**From:** Turchy, Michael A  
**Sent:** Monday, July 7, 2025 10:05 AM  
**To:** Annino, Amy; Jamison, John  
**Cc:** Amschler, Crystal C CIV USARMY CESAW (US); McHenry, David G; Wojski, Paul A; Pjetraj, Michael; Bukowy (HNTB), Kat A  
**Subject:** RE: Request for Additional Information: DWR 20250109 V3 - Hurricane Helene I-40 Pigeon River Gorge Emergency Relief Project

**Subject:** Request for Additional Information: DWR 20250109 V3 - Hurricane Helene I-40 Pigeon River Gorge Emergency Relief Project

# TIP PROJECT: I-40 PIGEON RIVER

**S-006R3: REVISED PERMIT DRAWINGS**  
**DATE: 06/03/2025**

NAD 83/NA 2011

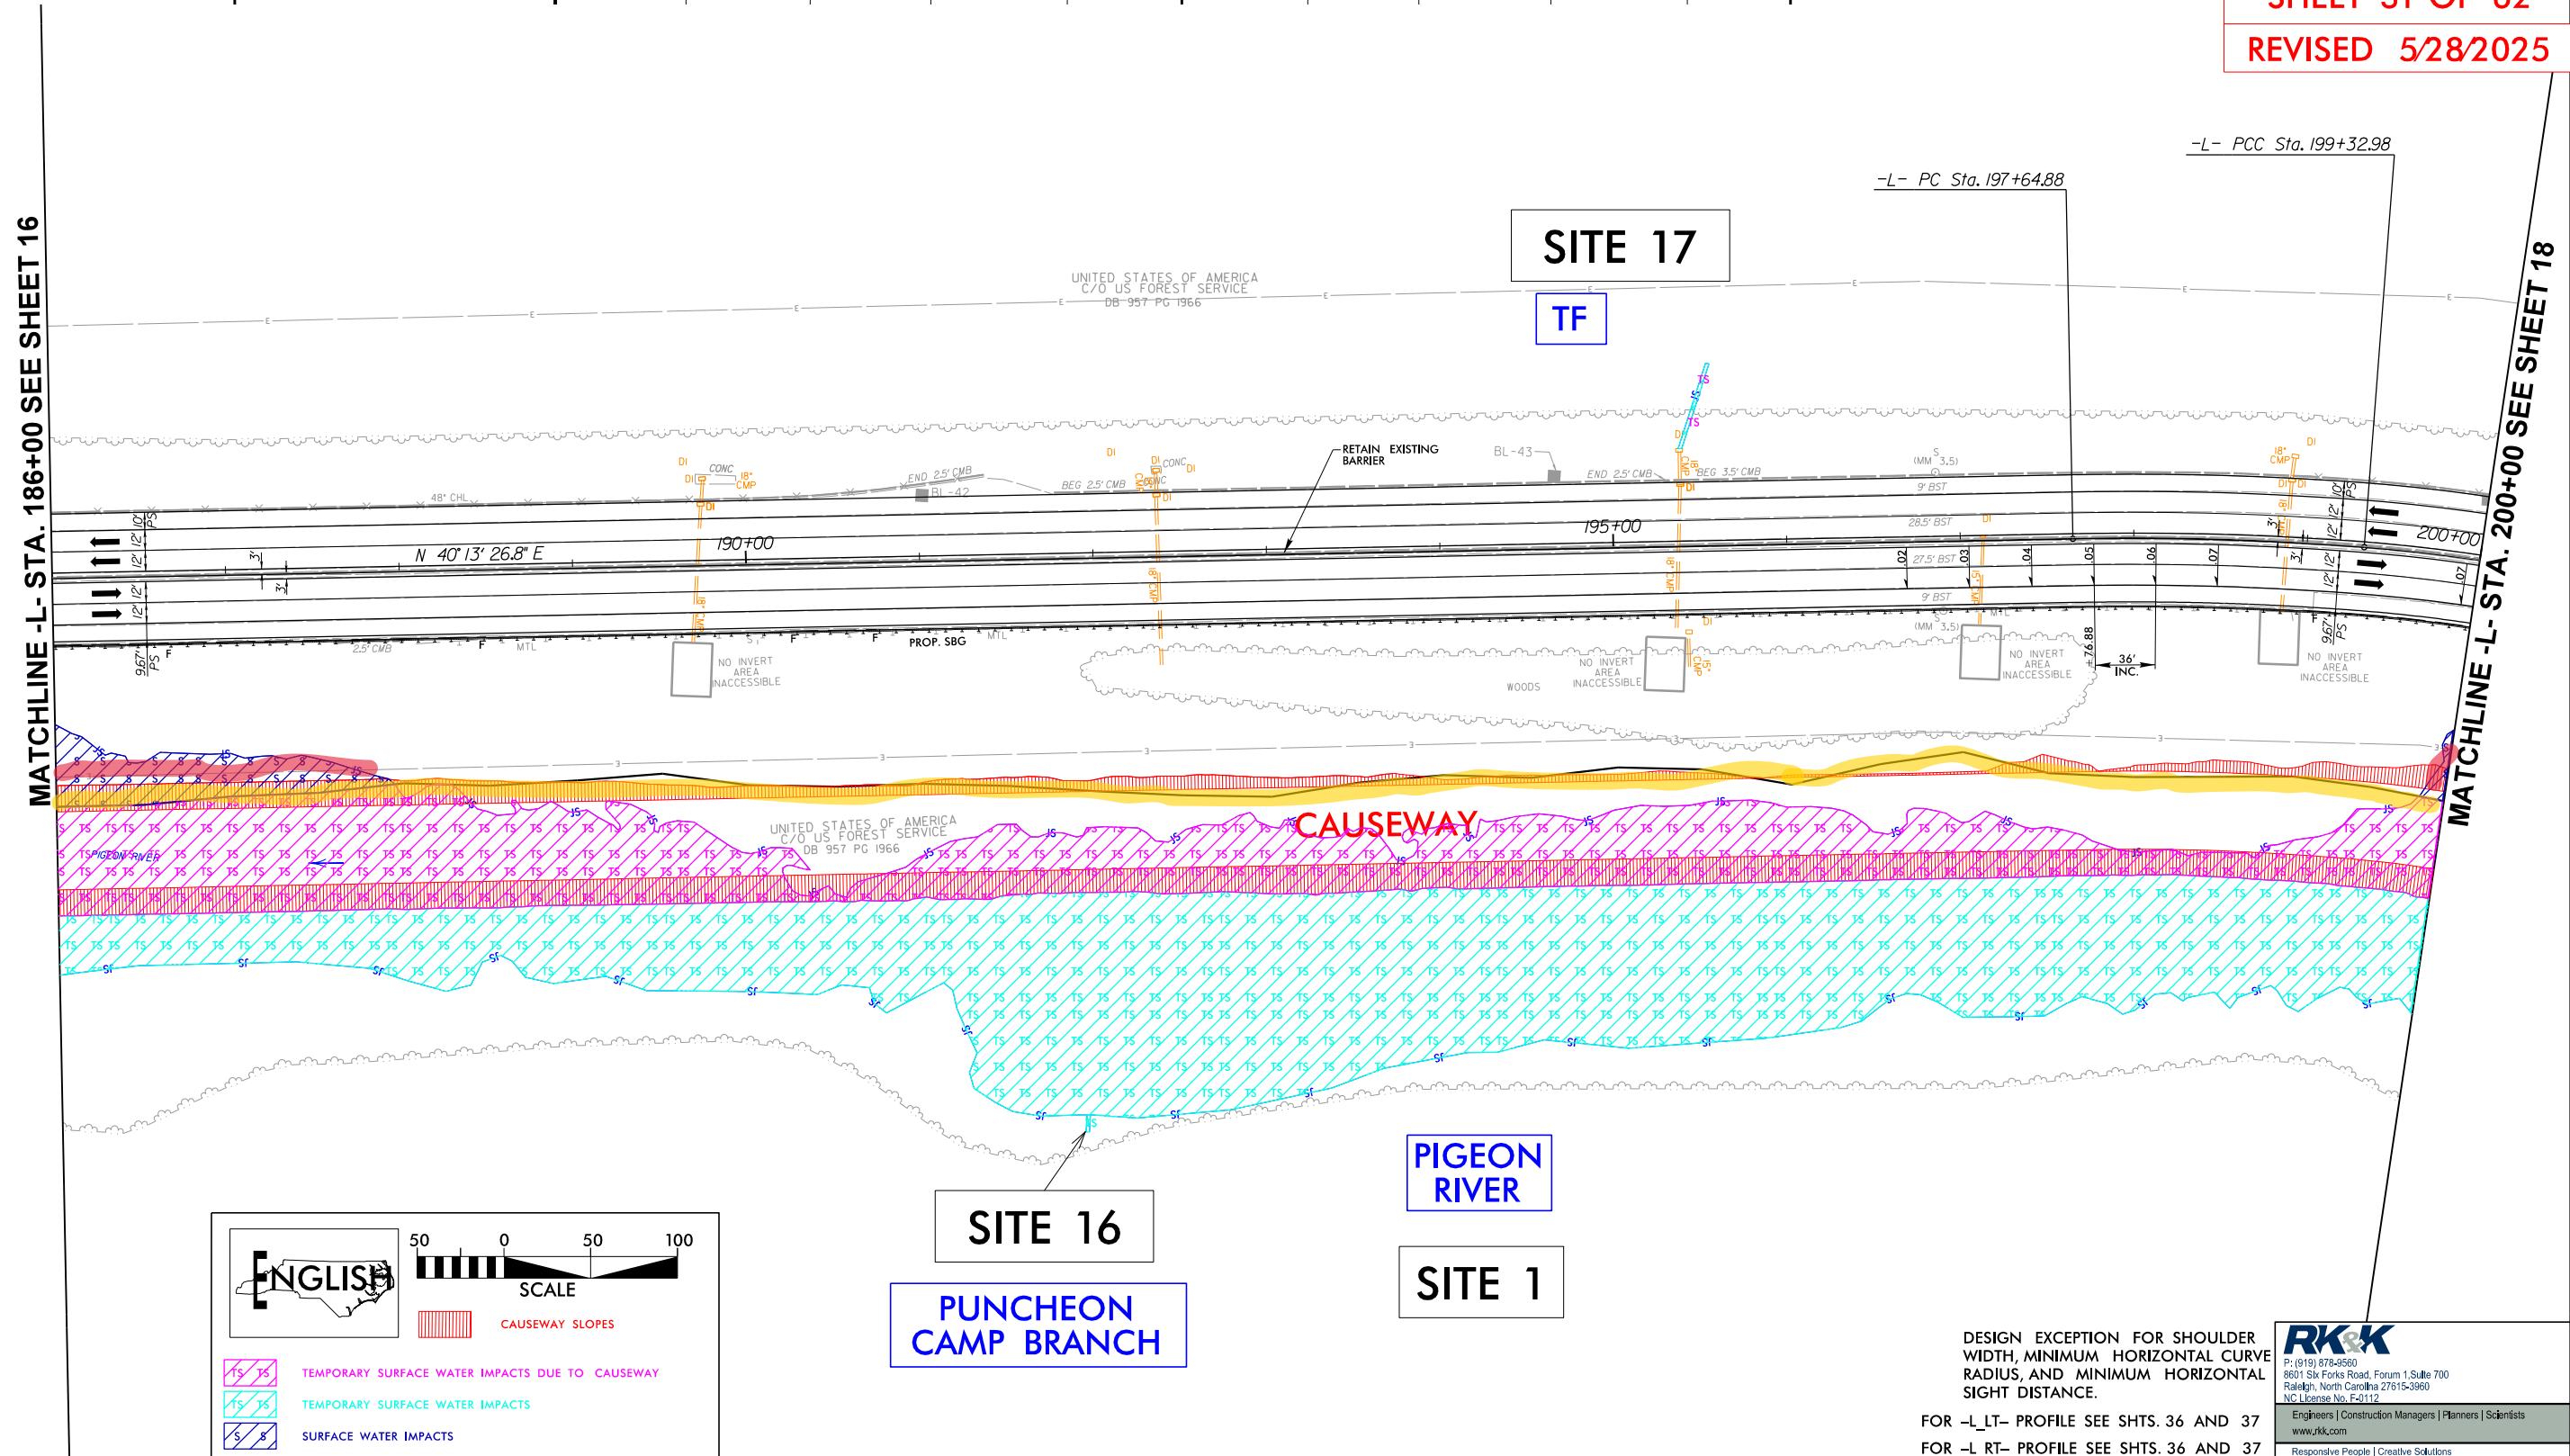
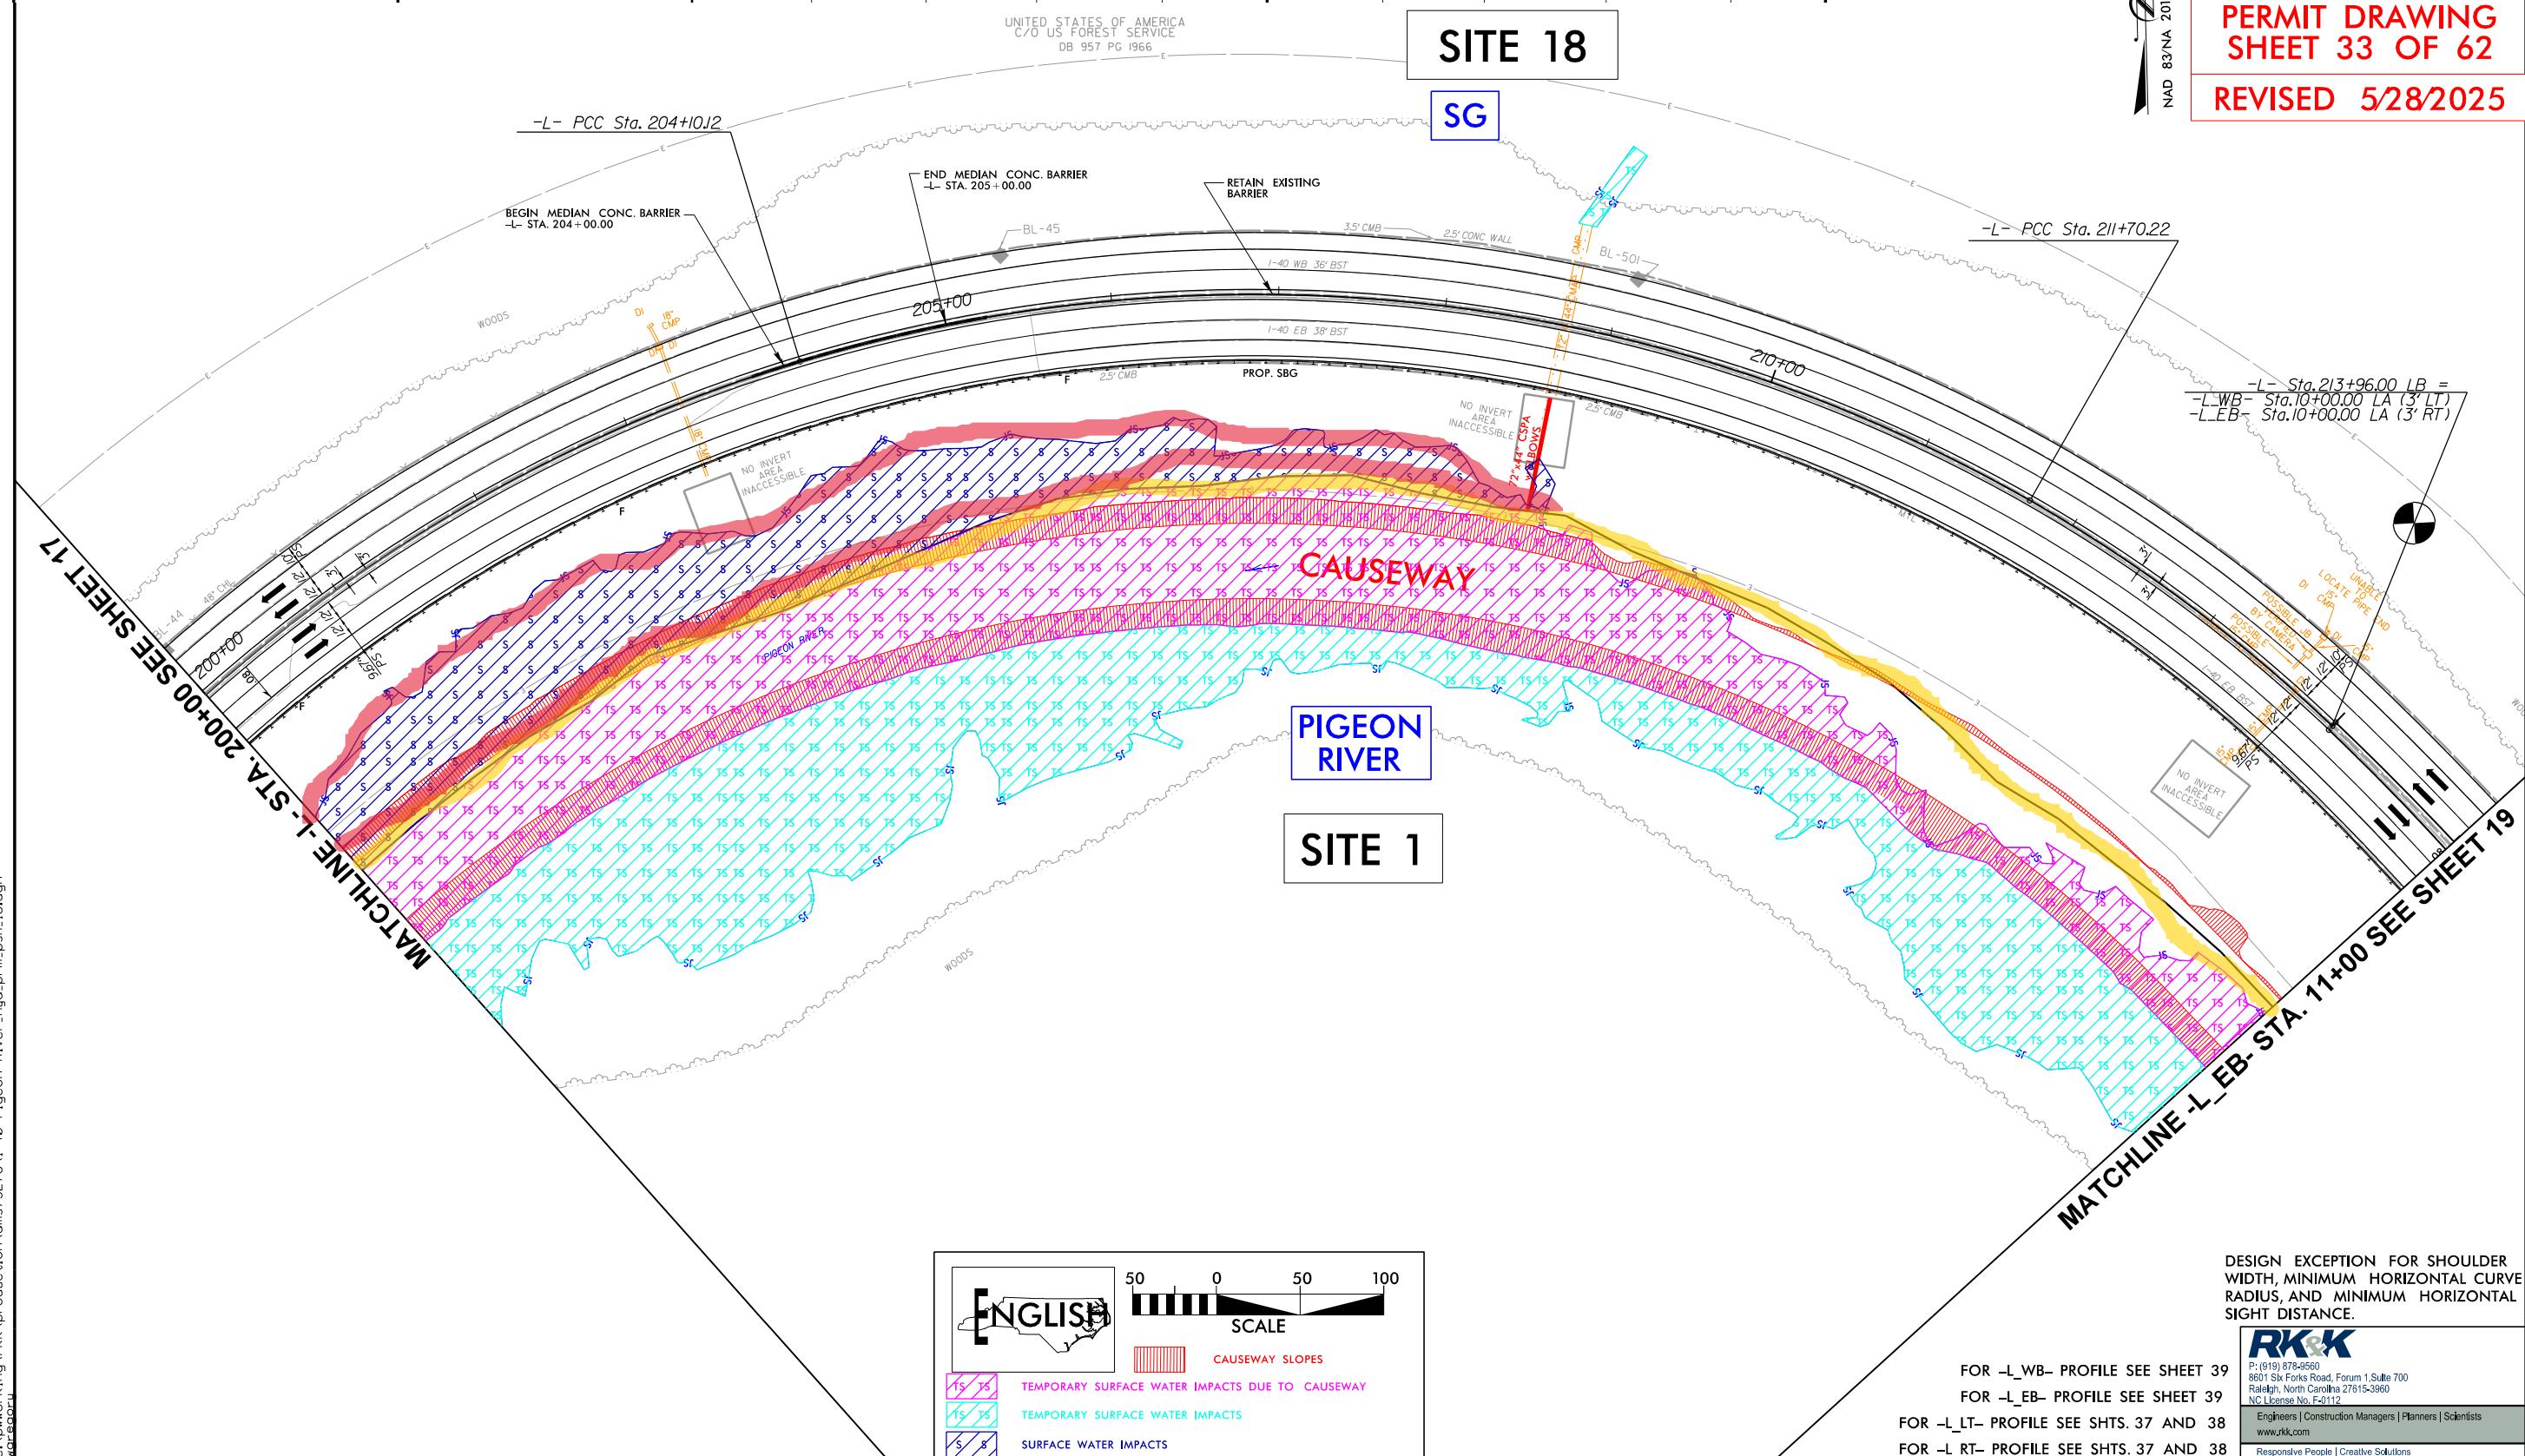
3. Please show the footprint of the proposed retaining wall through the project area

The proposed wall is located on the submitted set of drawings, and attached is a marked up set of drawings highlighting the wall for clarity, titled “**Drawings with Wall Highlighted**.”

The wall is highlighted in yellow. Wall impacts are highlighted in red.

Additionally, the impact summary table has been excerpted on each page to clarify the quantify the wall impact.

As previously noted, impacts are shown using the “scour zone limits” of the Pigeon River, as locating the ordinary high water mark post-Helene is not possible. Therefore, these drawings display a “worst case scenario” and are likely much lower than indicated.

The total proposed wall impacts to the Pigeon River are 12,116 linear feet.
